**TOWN OF WINDHAM
AMENDED SUBDIVISION PLAN
APPLICATION**

**for
The Heights at Colley Wright Brook
Cooper Ridge Road**

Amended Subdivision Plan Application

RE: Amended Subdivision Plan Application, The Heights at Colley Wright Brook, Cooper Ridge Road

NITRATE-NITROGEN GROUNDWATER ASSESSMENT MAP

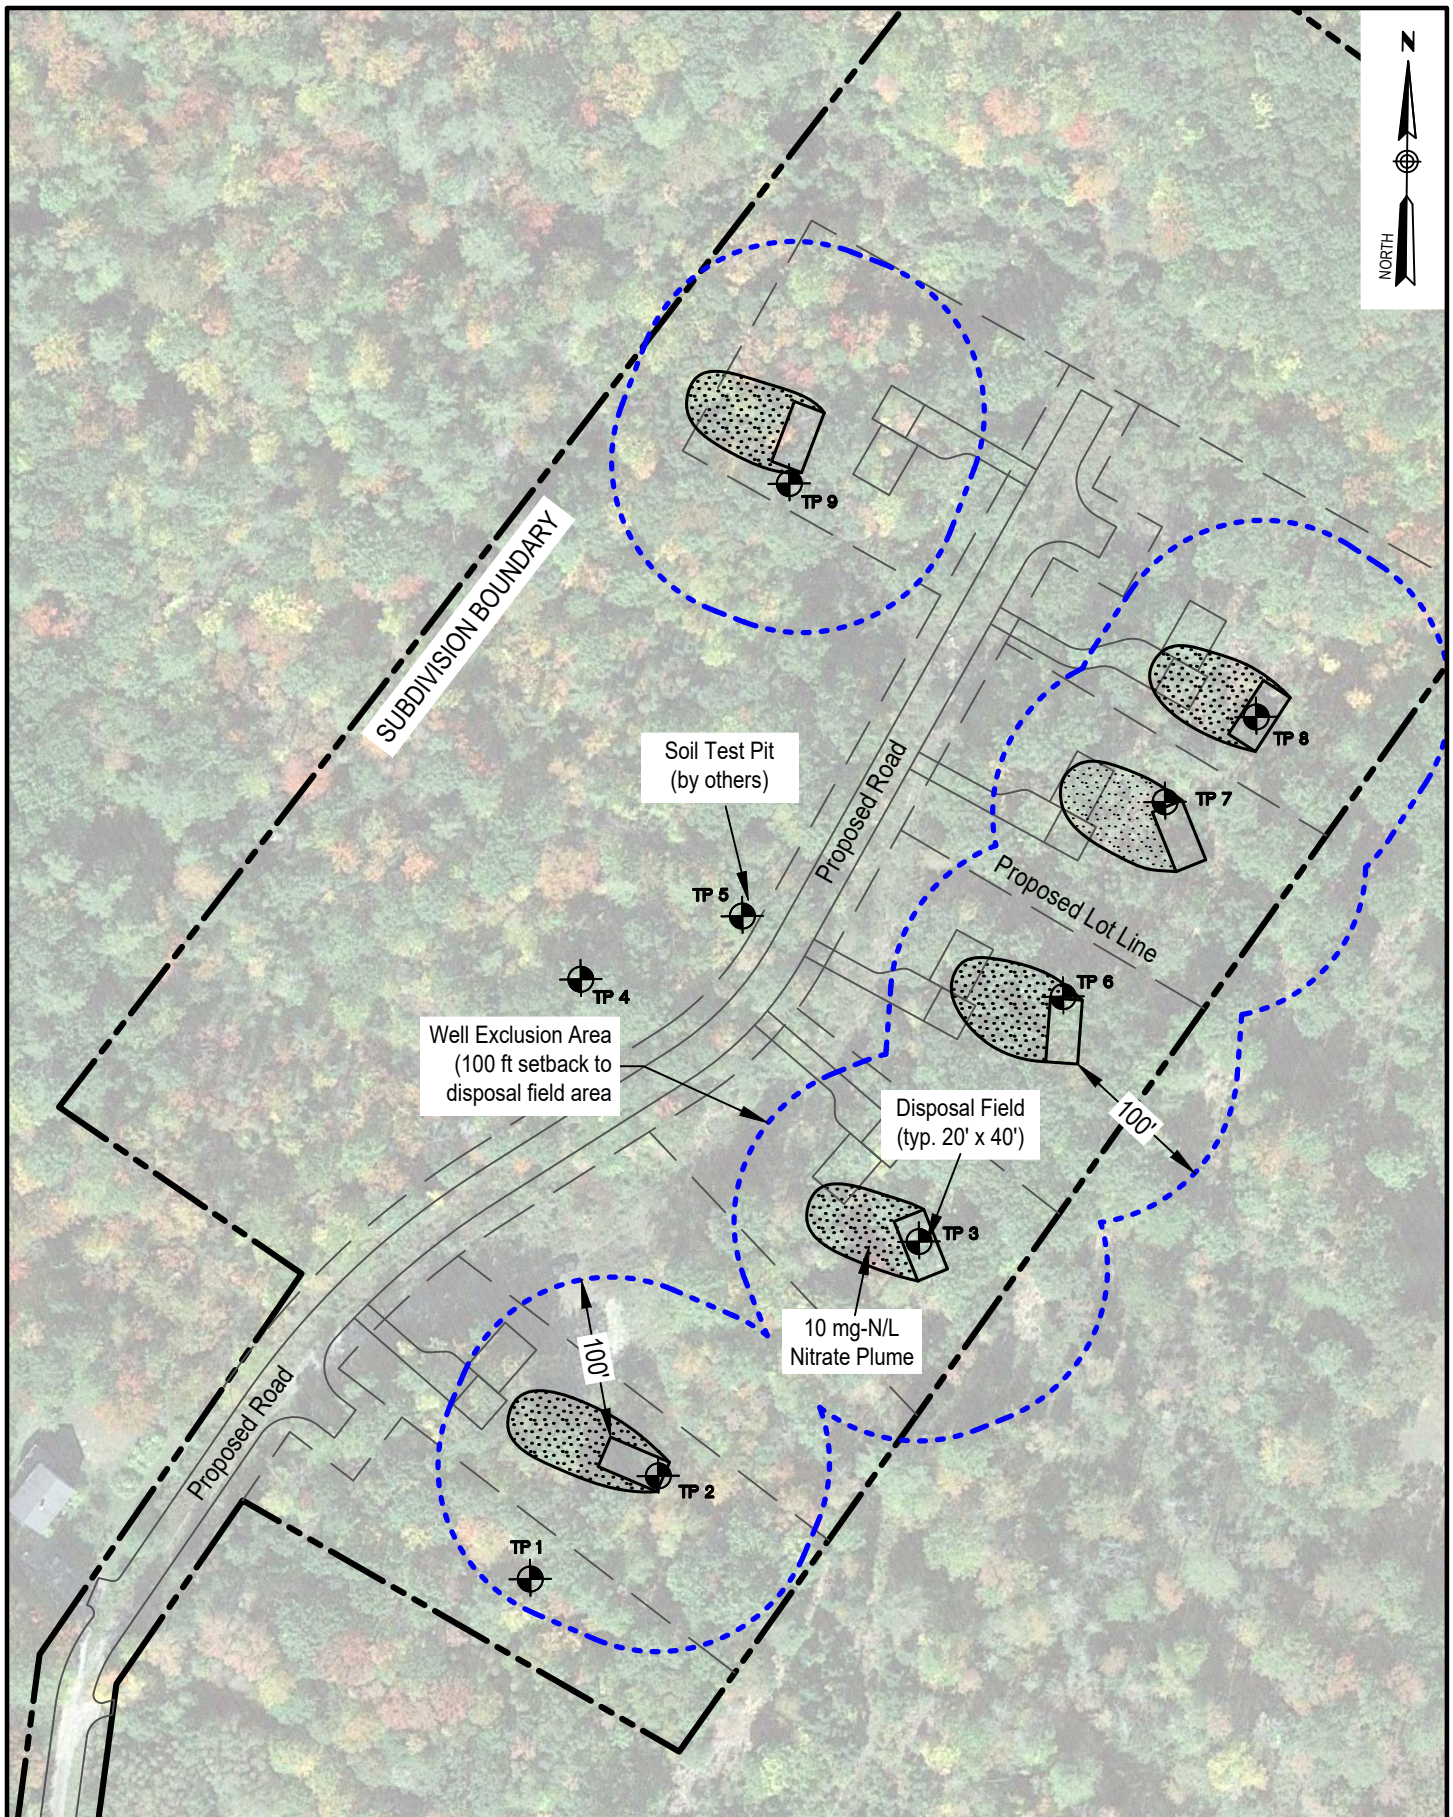
The estimated nitrate-nitrogen plume length for each of the disposal fields is 65 feet as depicted shown on Hydrogeologic Assessment Map provided as Attachment 2.

Individual water supply wells for each lot should be installed outside of the well exclusion area(s) shown on the Hydrogeology Assessment Map provided as Attachment 2. The well exclusion area includes the 10 mg-N/L plume area associated with each disposal field and 100-foot setback area around each disposal field. The well exclusion zones are approximate, as the location and size/type of disposal fields constructed may vary from those shown.
